DEVELOPMENT REVIEW COMMITTEE (DRC) COMMENT REPORT

Project Name: Donuts at Sunrise Boulevard

Case Number: R15032

Site Plan Level II Review: 1858sf Restaurant Use

SITE PLAN

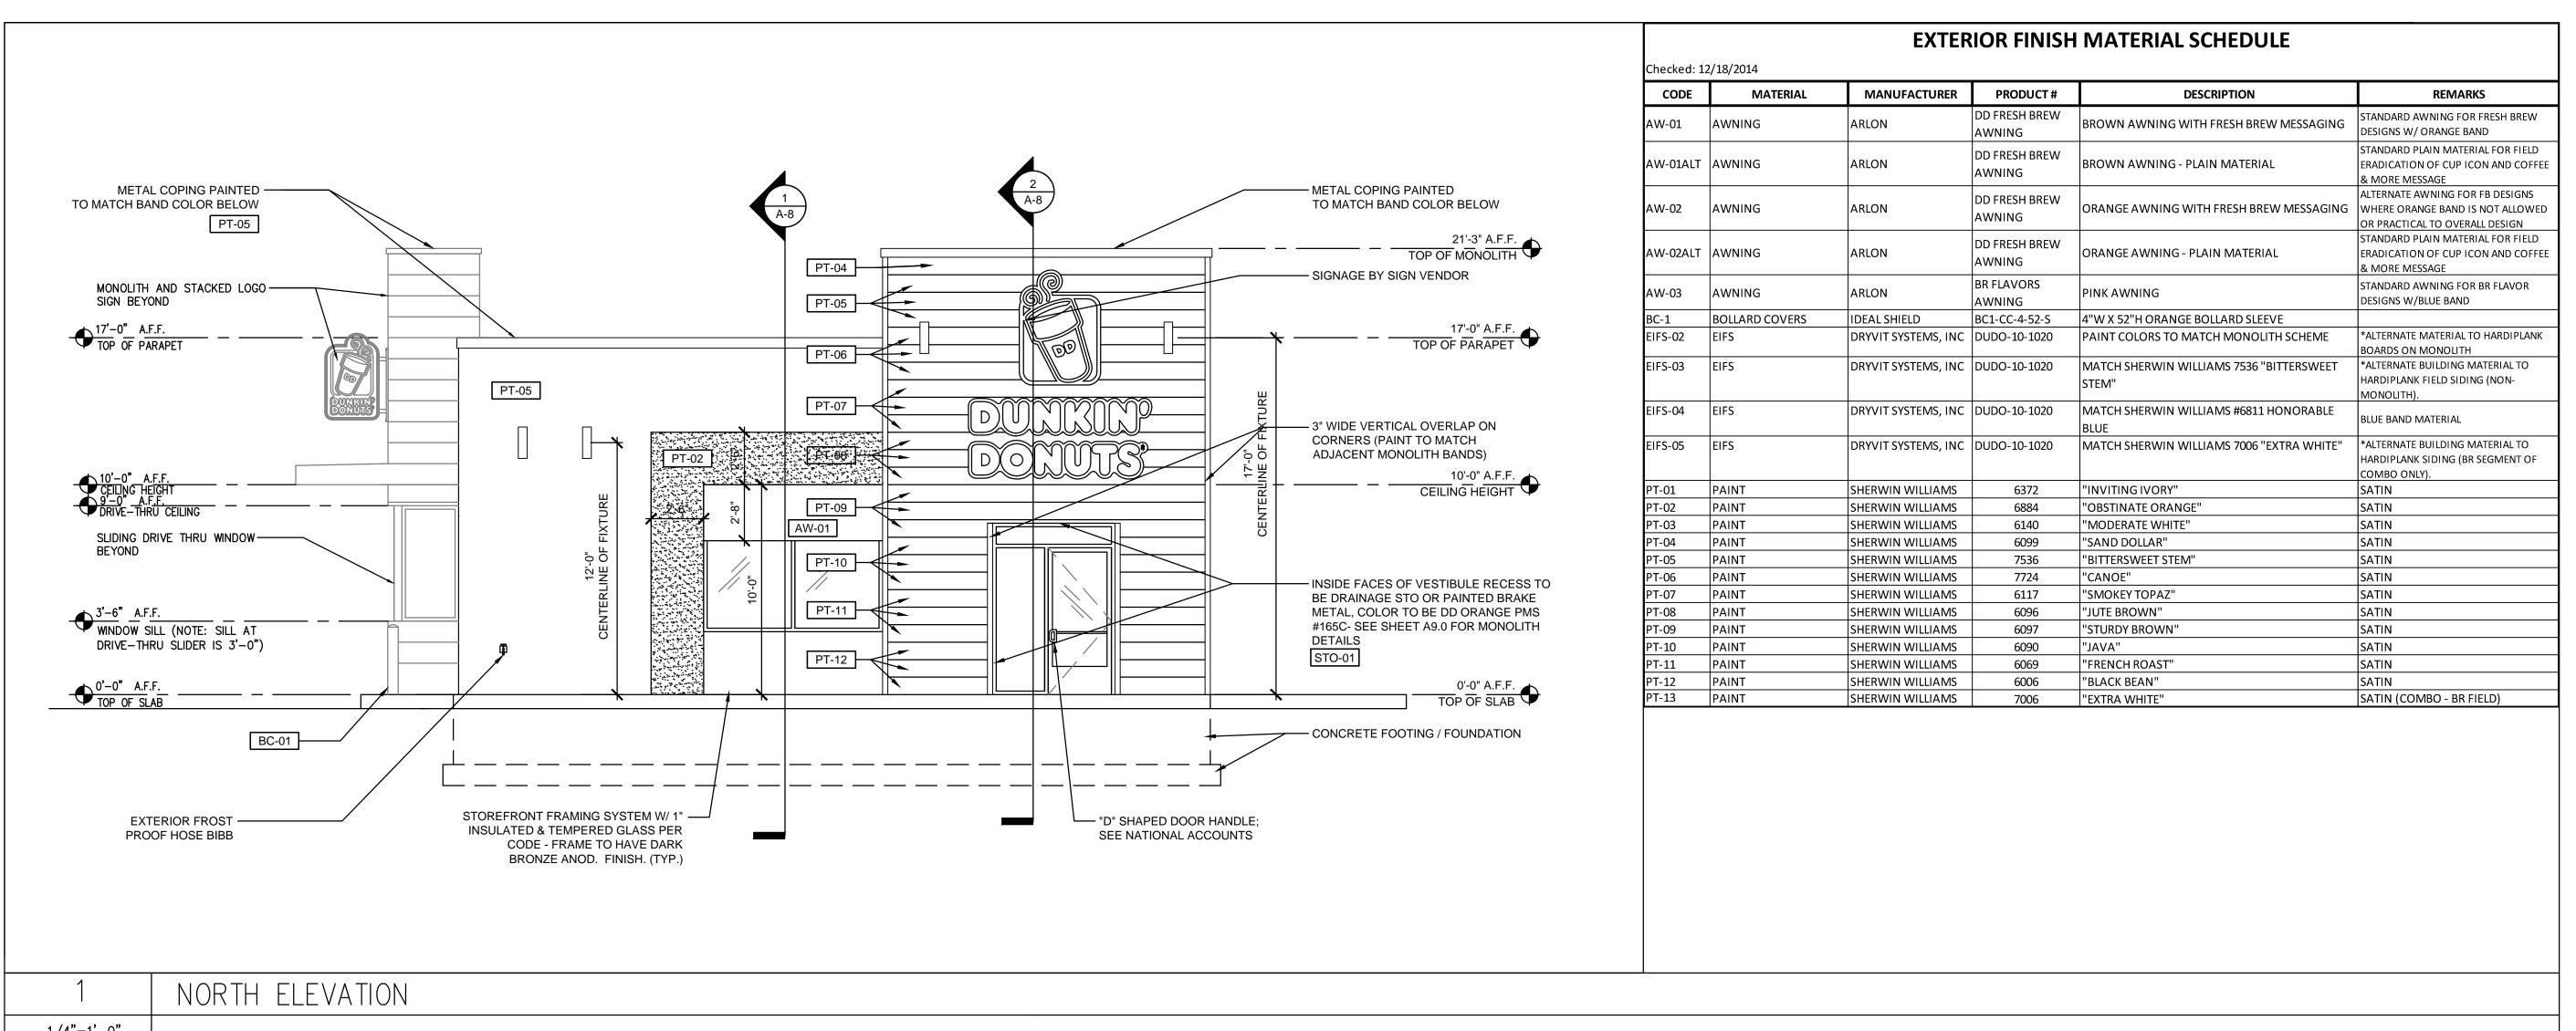
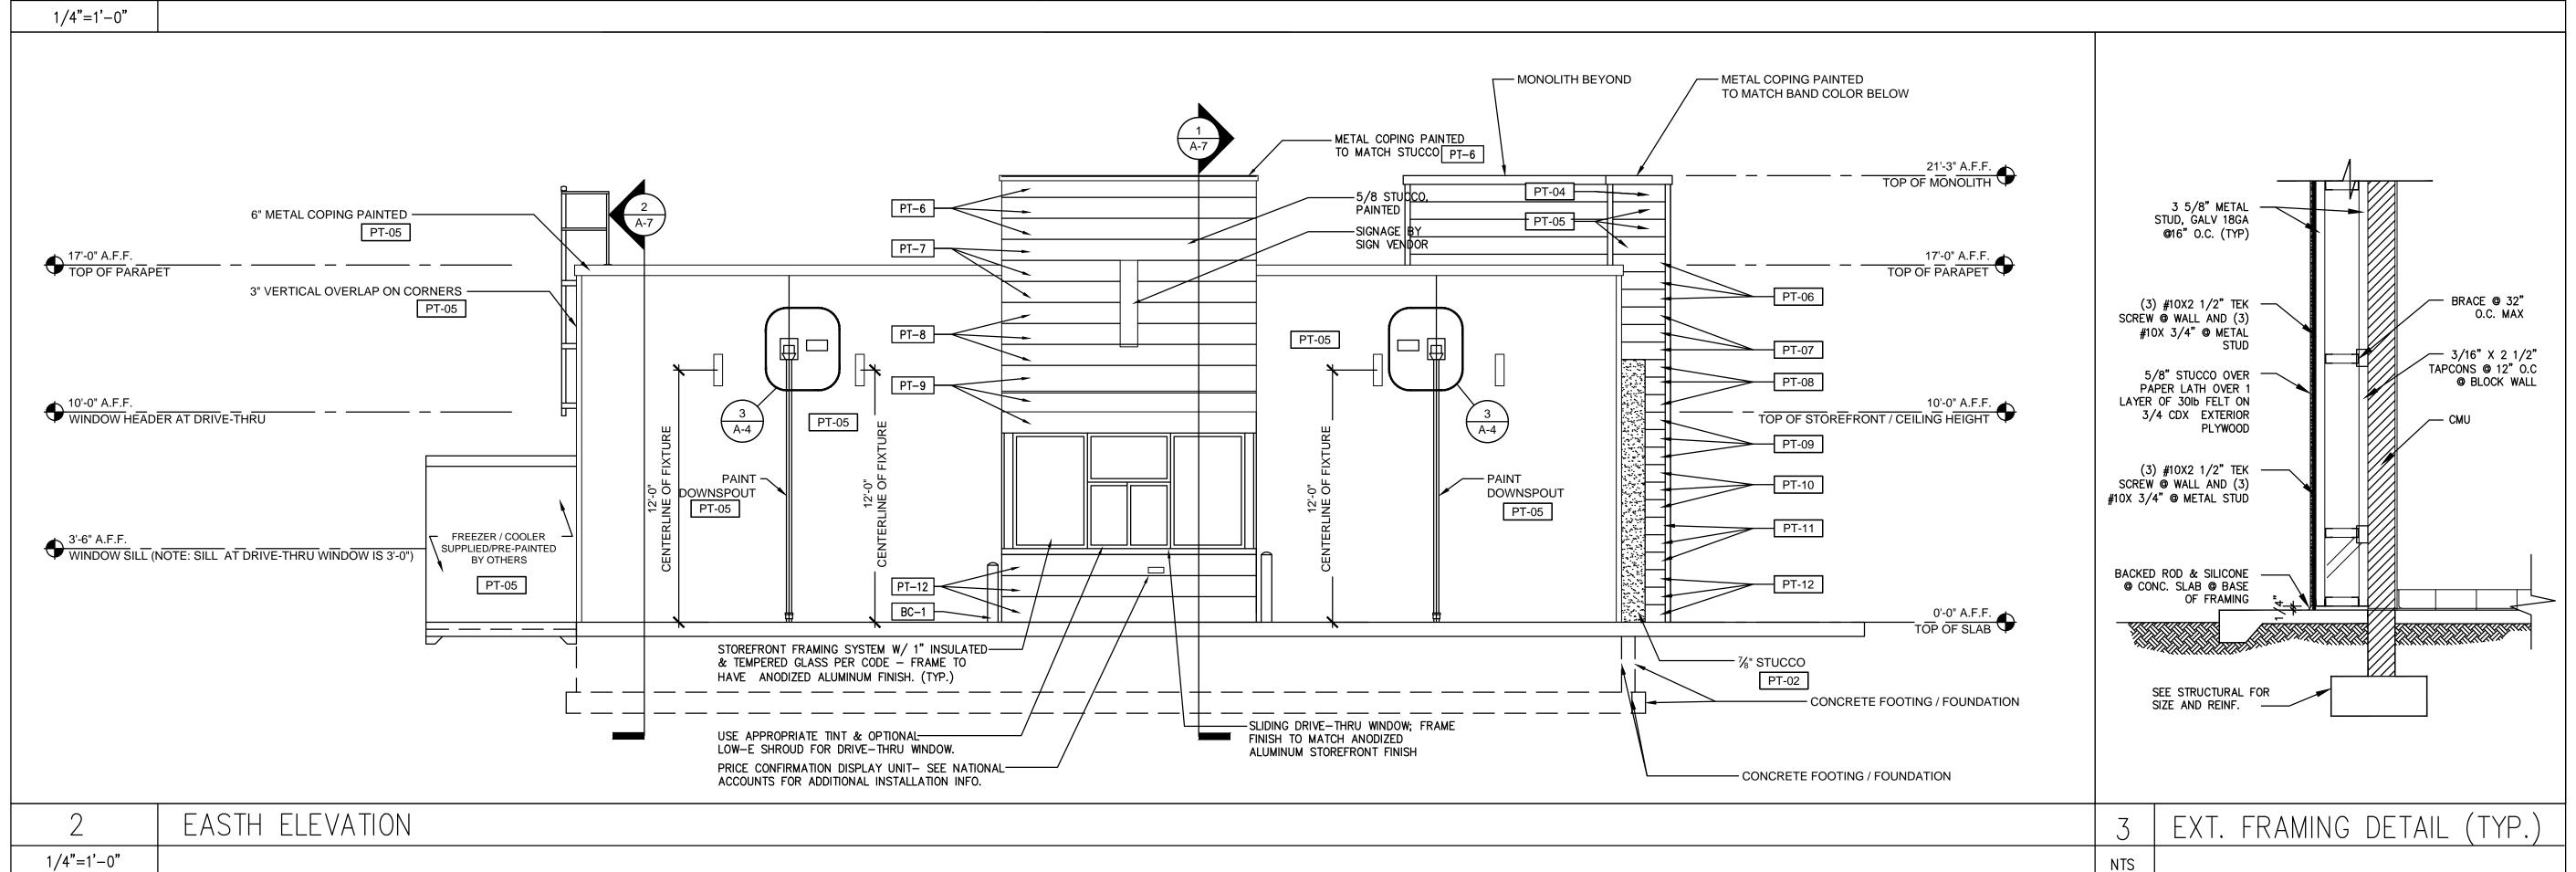
- Show existing and proposed property line / Right-of-Way boundaries and easements on Site Plan, including corner chord dedications. Discuss if 20' corner chord Right-of-Way dedication is needed at the corner of W. Sunrise Boulevard & N.W. 4th Avenue intersection.

- 7. Ensure **site plan** clearly indicates (labeled) locations of all solid waste and recycling containers and/or compactor(s) for all uses as proposed in application. Identify containers.

- 8. Provide on the site plan a garbage truck turning radii for City review. Drive aisle width and design configuration must allow for safe and efficient maneuverability on-site and off-site. Indicate how truck will circulate to/from/within property.

- Clearly label on site plan the location of enclosure(s), dumpster(s), recycling area(s), containers, etc. as applicable relating to Solid Waste / Recycling. Indicate on plans where users' accessibility is accommodated for all container areas.

A-5

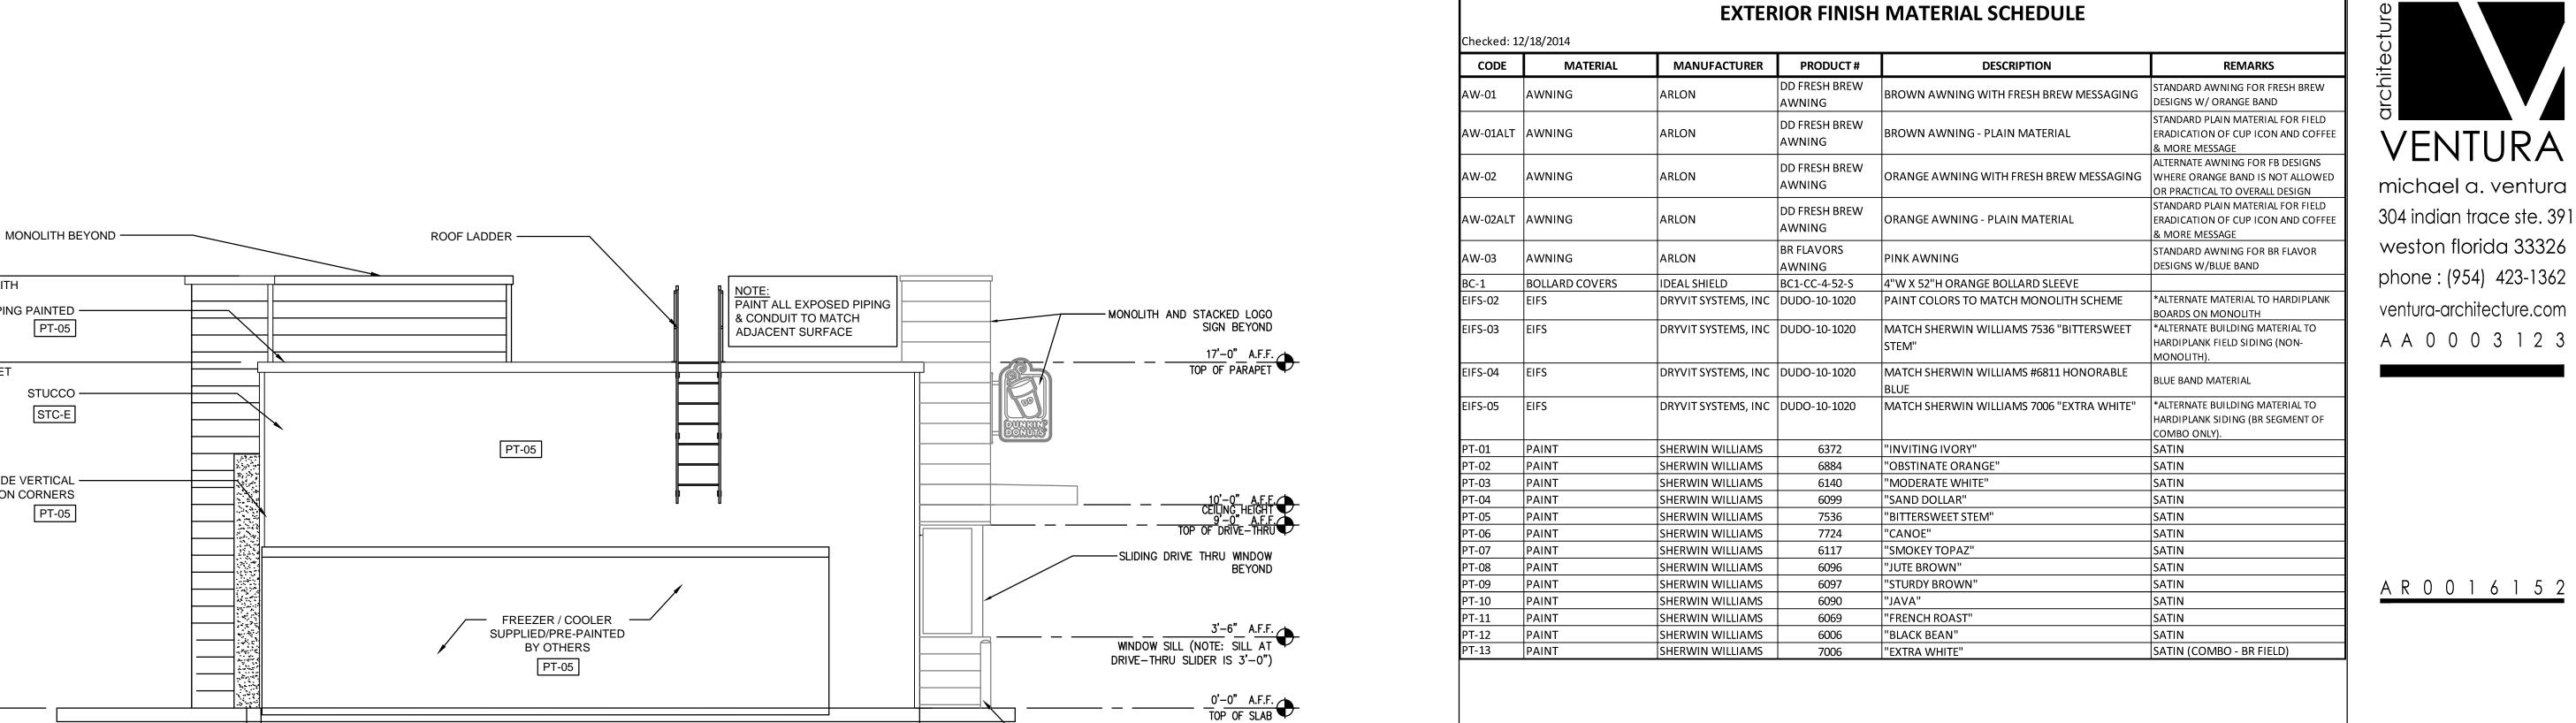
- 8) Pursuant to ULDR Sec. 47-25.3.A.3.b, Control of Appearance, facades facing residential properties shall be architecturally enhanced. Please consider a more active building façade, such as adding fenestration by incorporating windows, etcetera and/or a facade treatment that improves the aesthetic appearance and overall building composition/articulation as it relates to the residential context.
